MEMORANDUM

Date: 9/1/2016
To: Planning Commission
From: Tom Smith, Associate Planner
Re: 420 Claire Place – Determination of Substantial Conformance

DRAZAN RESIDENCE
420 CLAIRE PLACE
MENLO PARK, CA 94025

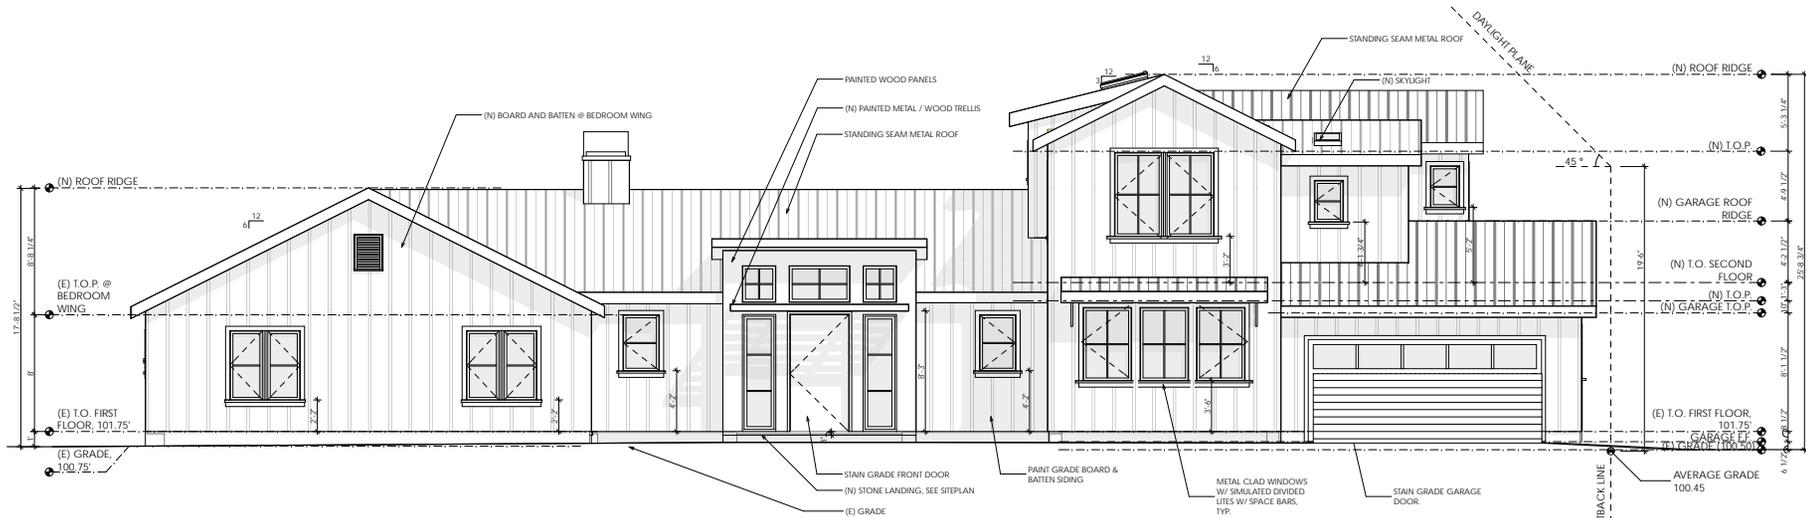
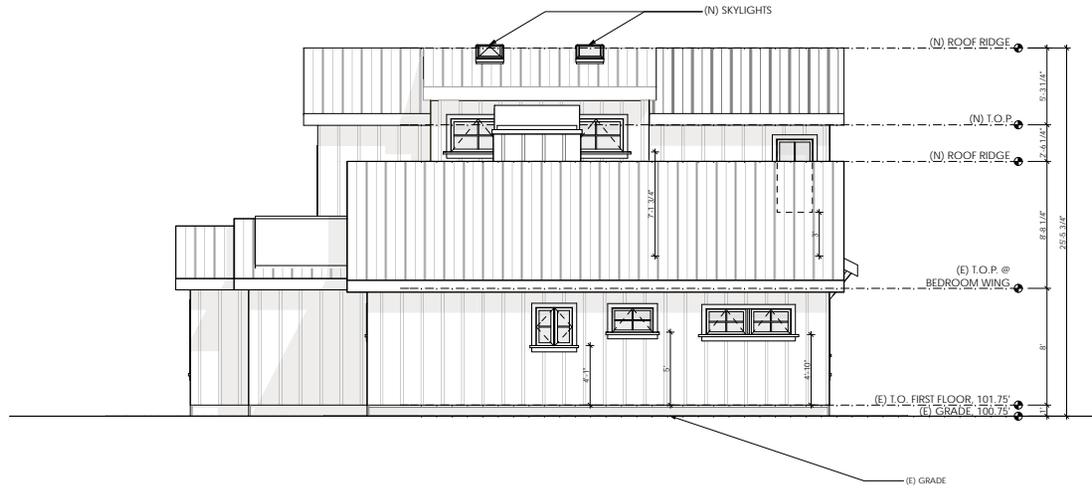
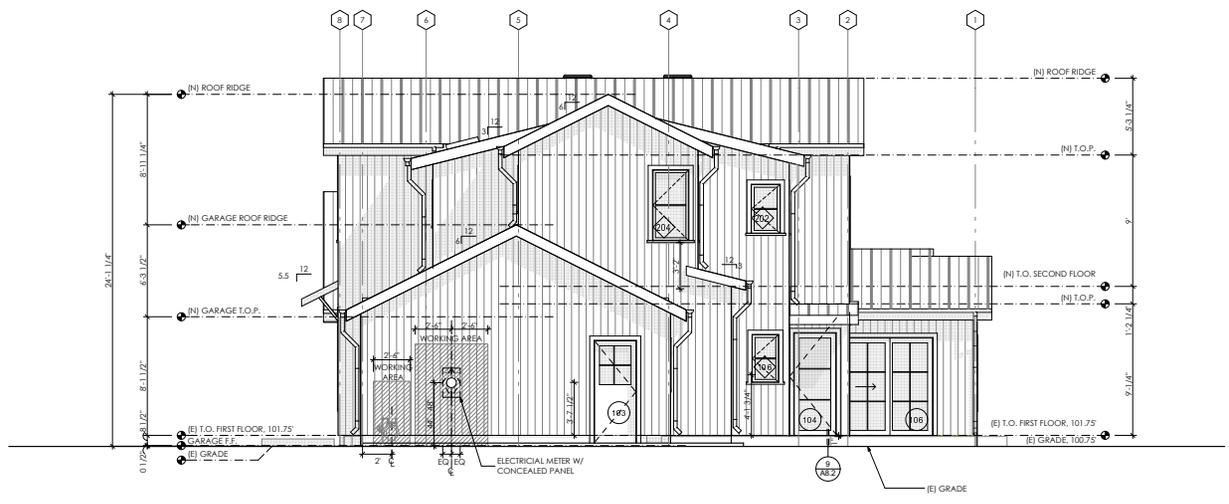
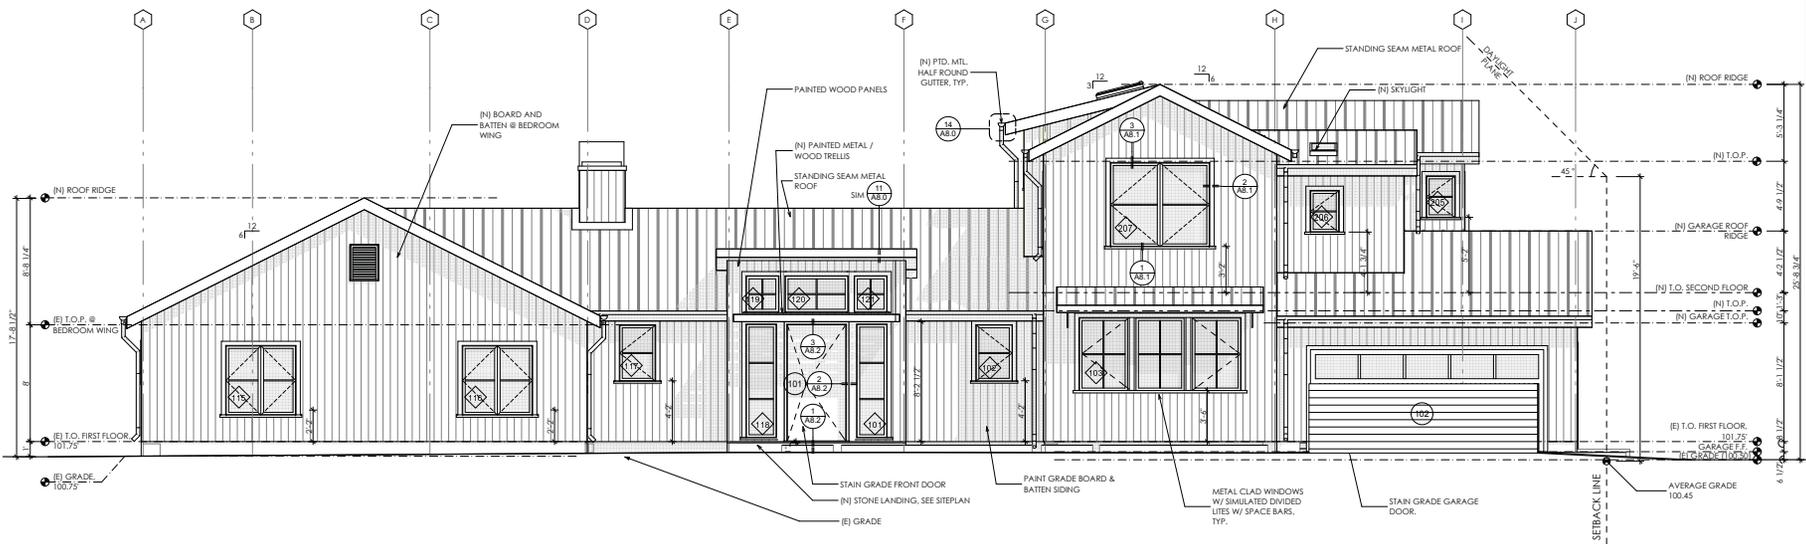
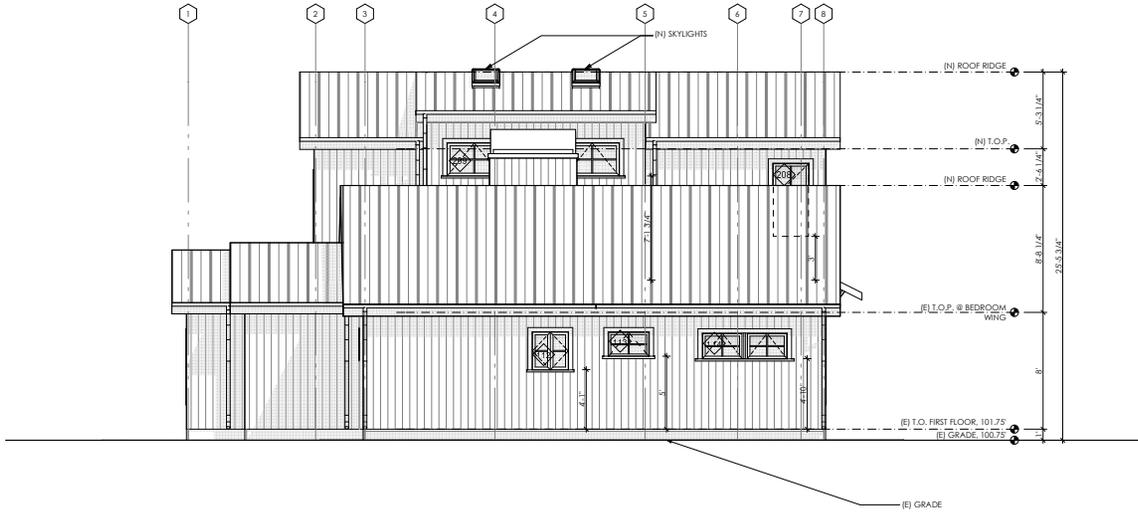
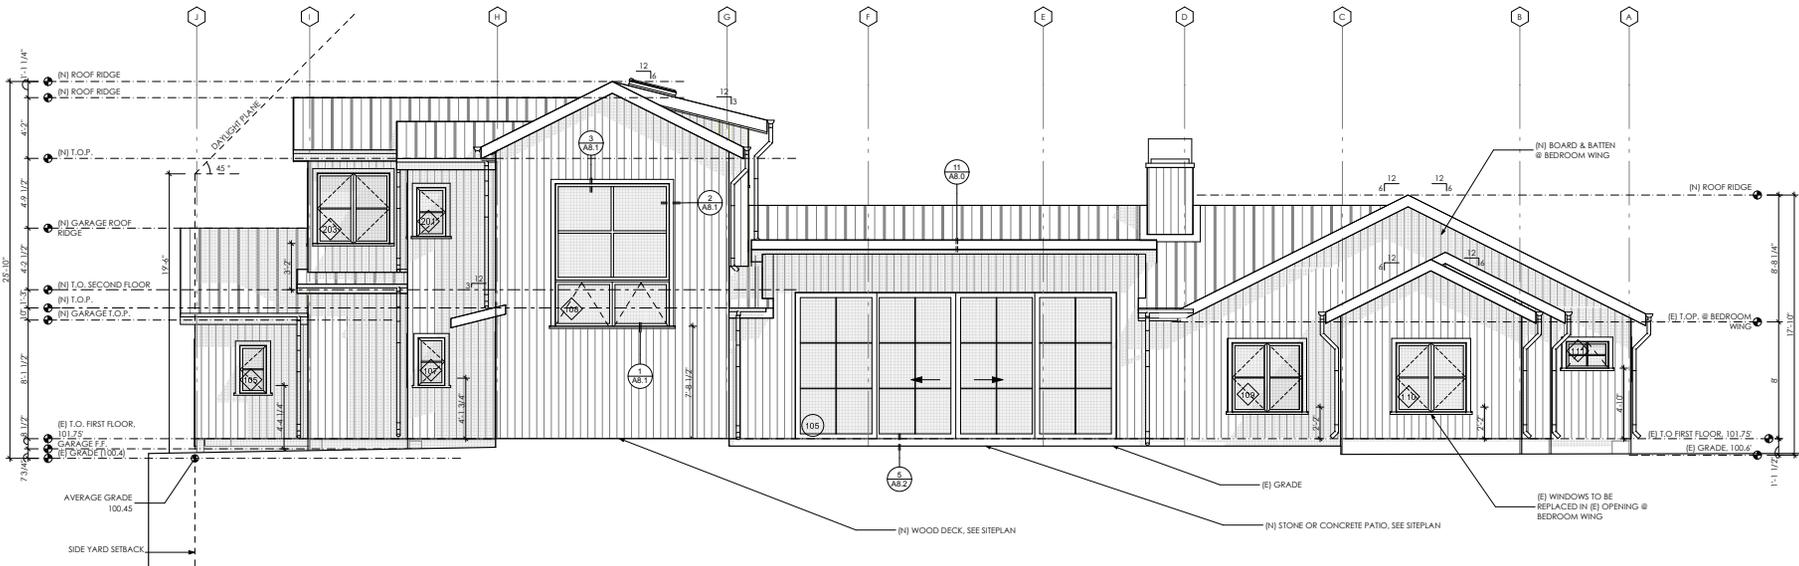
The applicant is requesting to modify the approved elevations (Attachment A) by using vertical wood siding across all sides of the exterior of the residence, as opposed to the board and batten siding shown on the original plans. The applicant states that the proposed material change would help differentiate the residence from a home under construction next door at 440 Claire Place, as well as other new residences in the vicinity, all of which are clad in board and batten siding. The proposed vertical wood siding would maintain the vertical pattern of the board and batten siding and the overall character of the proposed residence, but would provide sufficient differentiation from the neighboring residence. In addition, first-floor garage windows on the approved right (east) elevation would be removed. The applicant has submitted a project description letter and revised elevations, included as Attachments B and C, respectively.

We propose to change the siding on our home that is being currently remodeled. Along with Ana Williamson Architect (AWA), we originally submitted a proposal with board and batten siding. Our immediate neighbor at 440 Claire Place has just recently built a new "spec" home that is board and batten. Many of the new construction homes in our area are made with board and batten. We would prefer to avoid a home with an identical exterior to our neighbor's new home. Hence, we propose vertical wood siding. We believe this exterior change request is in keeping with the initial AWA design, theme, and intent to provide the neighborhood the variety that it needs and the quality and curb appeal that our neighborhood reflects and desires going forward.

- The overall integrity of the architectural design is maintained with the proposed change in siding. The vertical wood siding would continue to provide similar material patterns as the approved board and batten siding, and would be consistent with the overall modern farmhouse style. However, the proposed vertical wood siding would help differentiate the subject residence from other residences in the vicinity that are being constructed using board and batten siding.
- The removal of the garage windows from the right (east) elevation would not affect the overall integrity of the architectural design, and would not result in any potential privacy impacts to neighbors.
- The project modification meets all development regulations in the R-1-S zoning district with respect to setbacks, height, daylight plane, floor area limit, and building coverage.
